**Metro Manila Subway Project Phase 1
PACKAGE CP104: (ORTIGAS NORTH AND ORTIGAS SOUTH)**

ITEM NO.	REFERENCE/CLAUSE/SECTION	QUERIES	RESPONSE
----------	--------------------------	---------	----------

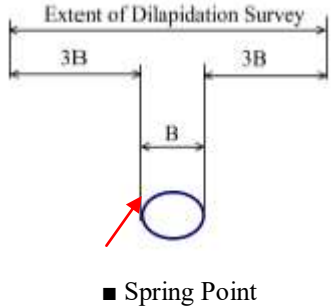
21.	DRG No. STN-CE-OS-0050, 0051 ORTIGAS SOUTH STATION REINFORCEMENT DETAIL SECTION C-C SHEET 2/7, 3/7 DRG No. STN-CE-OS-0031 to 0034 ORTIGAS SOUTH STATION STATION SOUTH END GENERAL DRAWING SHEET 1/4 to 4/4, DRG No. STN-CE-OS-0036, 0037 ORTIGAS SOUTH STATION REINFORCEMENT DETAIL SECTION A-A SHEET 2/7, 3/7 DRG No. STN-CE-OS-0027 to 0030 ORTIGAS SOUTH STATION STATION NORTH END GENERAL DRAWING SHEET 1/4 to 4/4,	Ortigas South Station temporary D-Wall at the ④ and ⑩ have the Slab connection couplers only on TBM shaft side. We assume that the Ortigas South Station ⑩ D-Wall shall remove after ⑩-⑫slab and ⑩column constructed and in time for excavation and slab construction on the station center side. And we also assume the Ortigas South Station ④D-Wall in the same way as above. Is this assumption is correct? If this assumption is not correct, please provide the Slab connection couplers Drawings of the station center side, as same as Ortigas North Station.	Construction sequence needs to be planned by contractor considering the construction schedule.

67.	DRG. NO. STN-MEP-FPS-ON-3241	We interpret the tapping point for the Wet Stand pipe & Hose System for the tunnel shall be at the	Respect the distance given on the tunnel side; but the reference point on the beginning or the end portions shall be

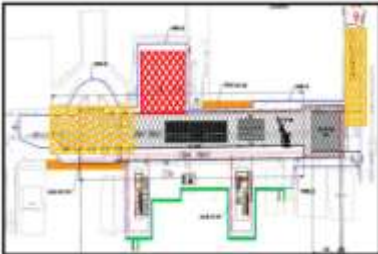
ITEM NO.	REFERENCE/CLAUSE/SECTION	QUERIES	RESPONSE
		end of the fire pipes indicated on the plan layout at the platform level of the fire protection (DRG. NO. STN-MEP-FPS-ON-3241). Please confirm and advise.	besides the stations.
